From: Bull, Trishah <Trishah.Bull@kingcounty.gov>
Sent: Monday, January 30, 2017 10:32 AM
To: marywictor@comcast.net; Mike Ammerlaan
Cc: Lindsey Ozbolt
Subject: RE: Public Comment (0)--KC Trail ELST Segment 2B--SSDP2016-00415 Fwd3: Access to Beach Rights easement R.M. Kantonen

Dear Trishah Bull / King County, & cc: Lindsey Ozbolt / Associate Planner at the City of Sammamish for Public Comment on K.C. Trail - ELST

RE: Opposition to King County's Proposed 60% Plans Segment B

EXHIBIT 2

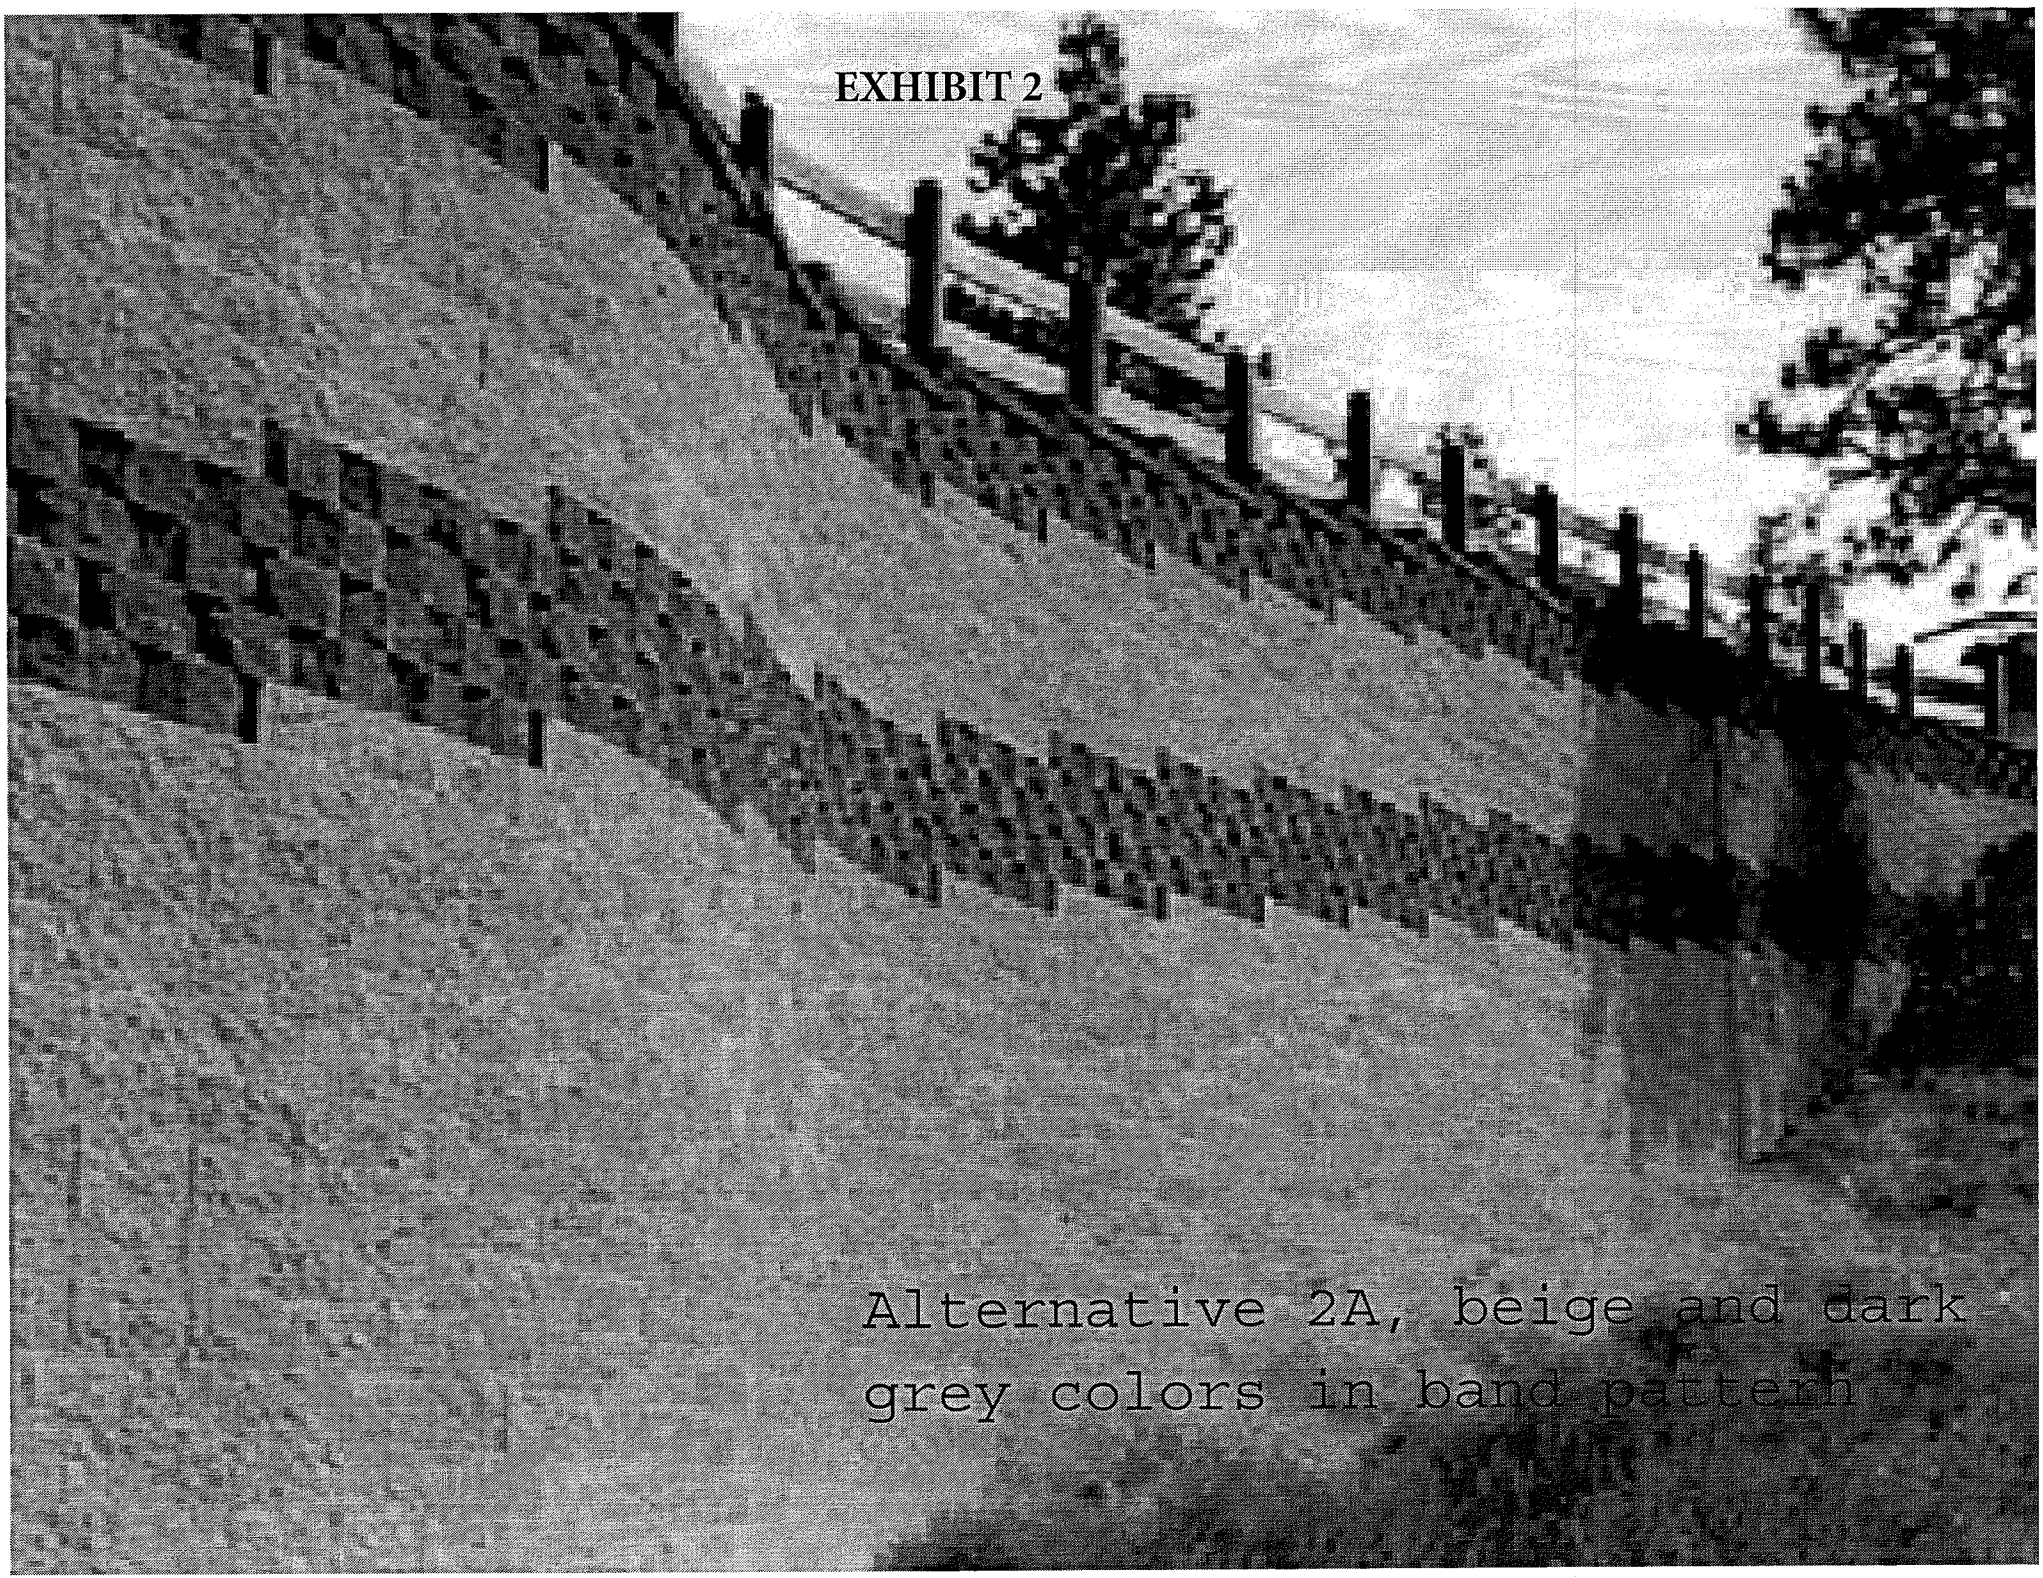
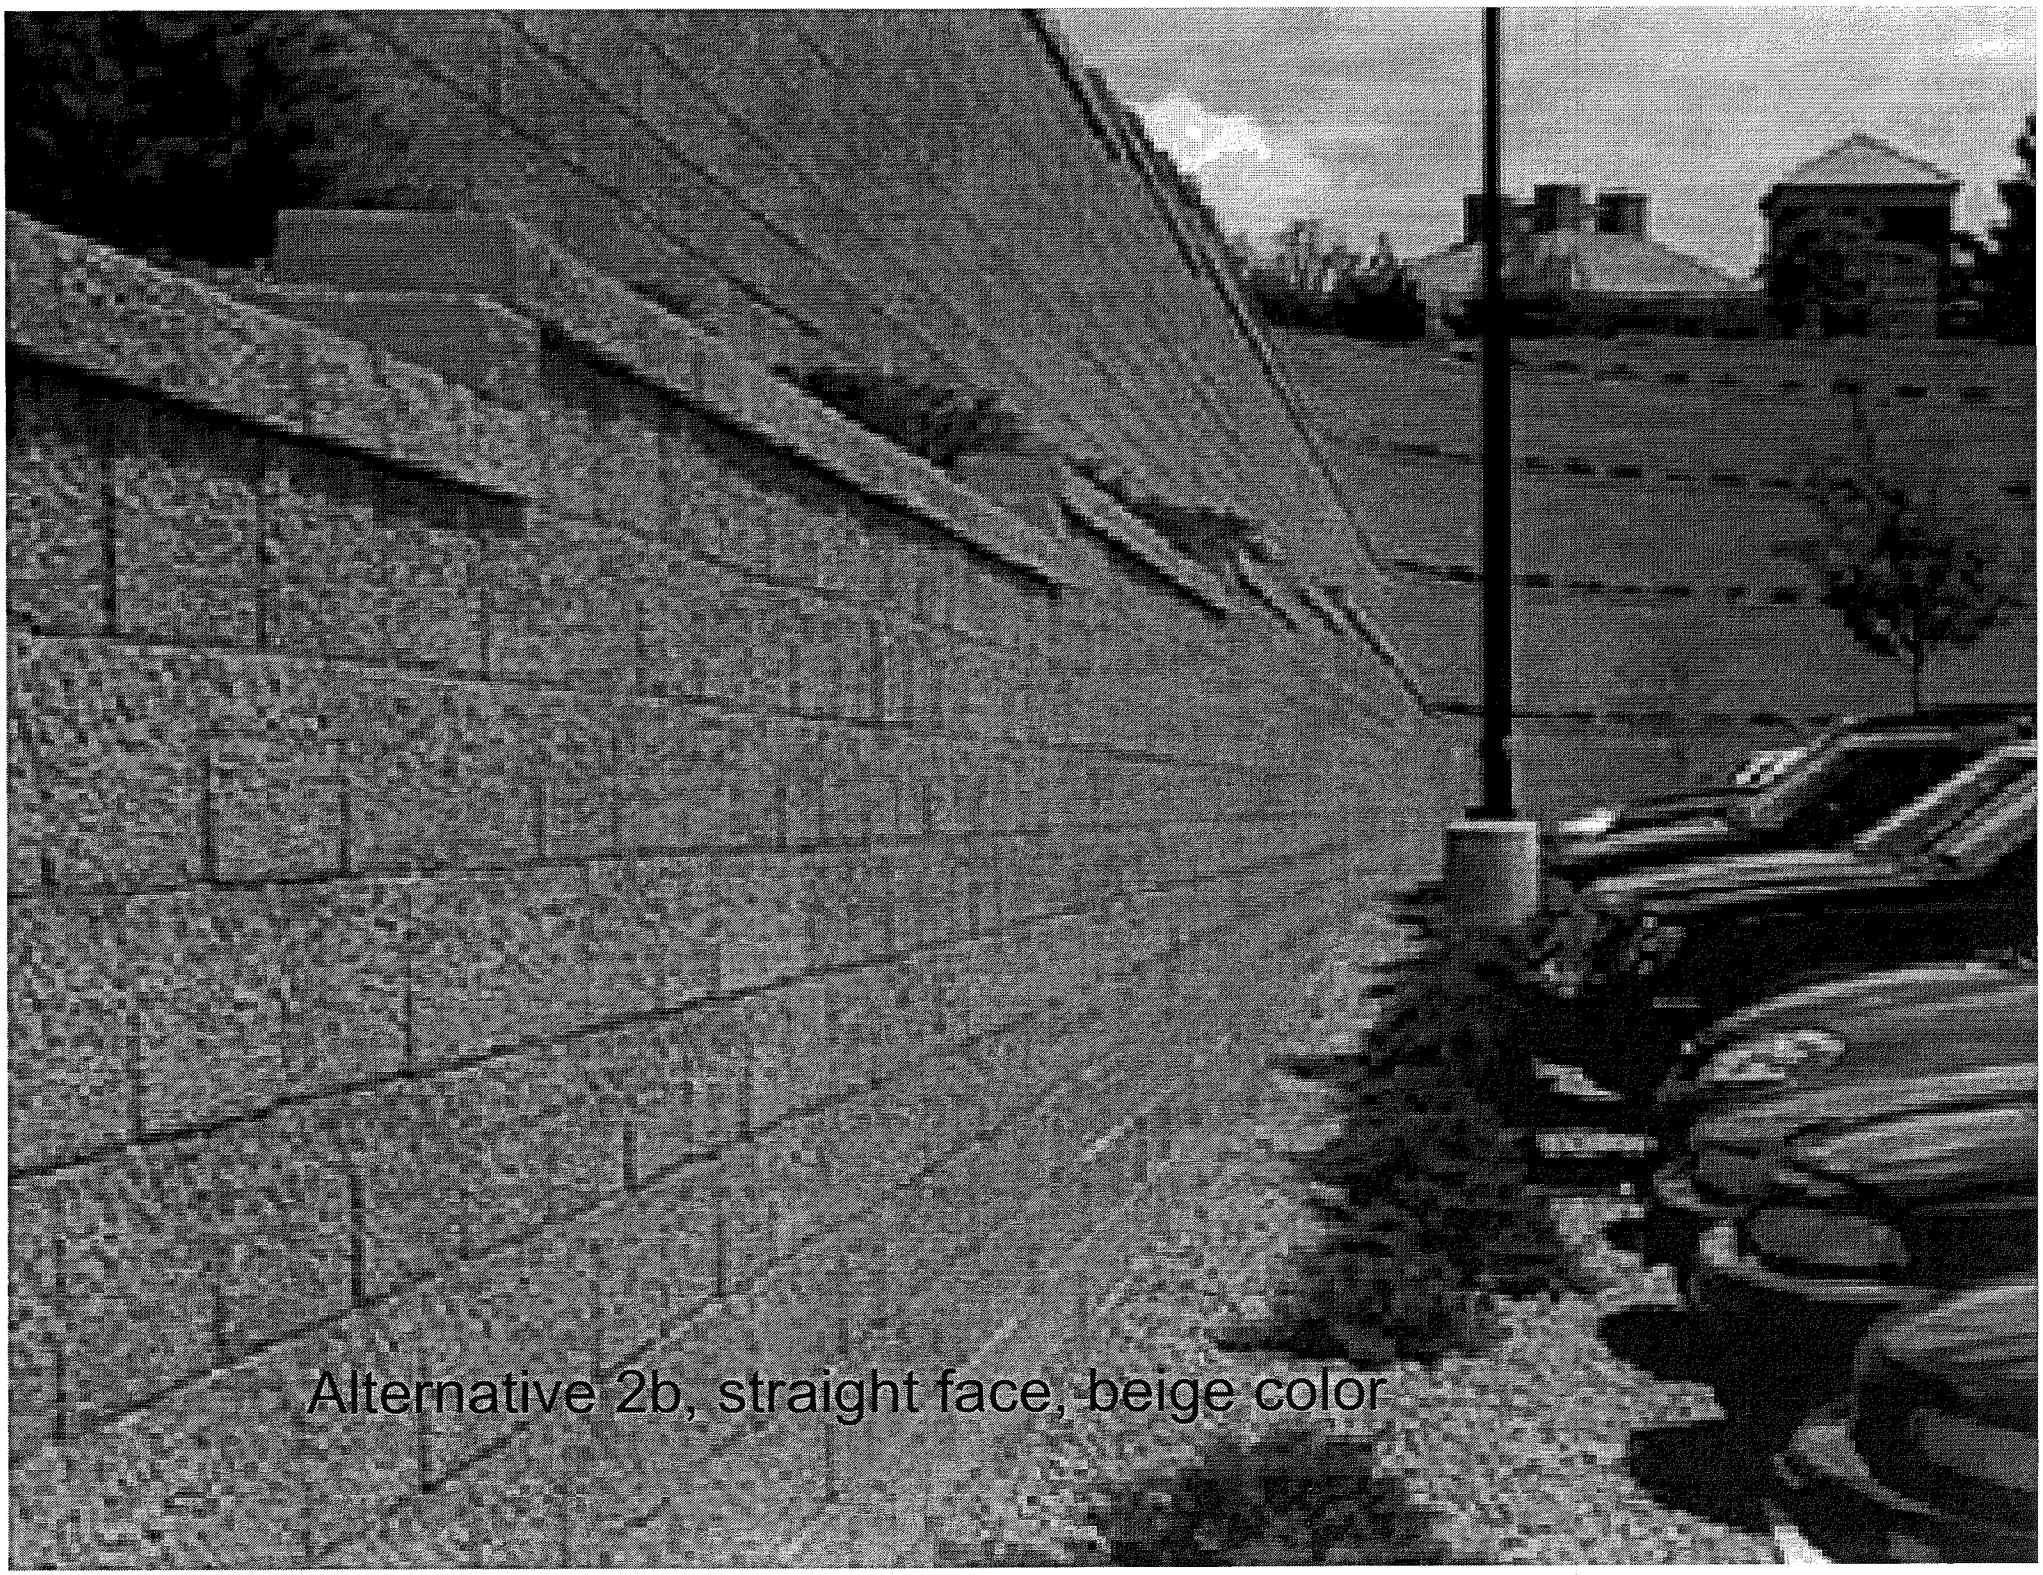
6. Chapman Wall: The County agrees to construct the proposed County wall in front of the Chapman residence (Wall 13A on plan sheet AL 10) on the same alignment as the wall in the existing construction plans for the adjoining property to the immediate south (Wall 13 on plan sheet AL 10). The County agrees to temporarily remove the driveway retaining wall constructed by Chapman. Chapman shall obtain three competitive bids from licensed and bonded contractors for rebuilding the wall. Chapman shall either accept the lowest bid, or if a higher bid is accepted, Chapman must agree to pay out-of-pocket the different between the higher bid and the lowest bid. The County agrees to pay Chapman a sum equal to the lowest bid, with the County's obligation capped at a maximum of $7,500, to compensate Chapman for the costs of rebuilding the wall following construction of the North Sammamish segment of the ELST. Payment shall be received by counsel for Chapman within 45 days of the County's receipt of the competitive bids. With respect to construction of the County's proposed retaining wall adjacent to the Chapman residence, the County shall give Chapman the option of choosing one of the styles/designs attached as **Exhibit 2**.
